Proposed Section A-A for Wyoming

Proposed plan view at intersection of Wyoming and Eagle Rock

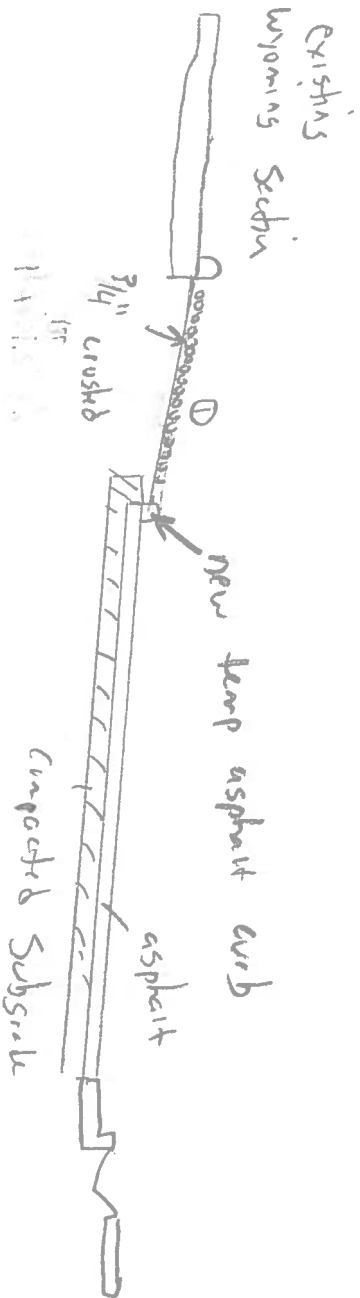
- ① Slope is near zero from STA 11+75 to 15+33.24
Slope is ~5 to 8% at STA 11+06
Slope is ~10% at STA 10+25, which is ~point of max grade change
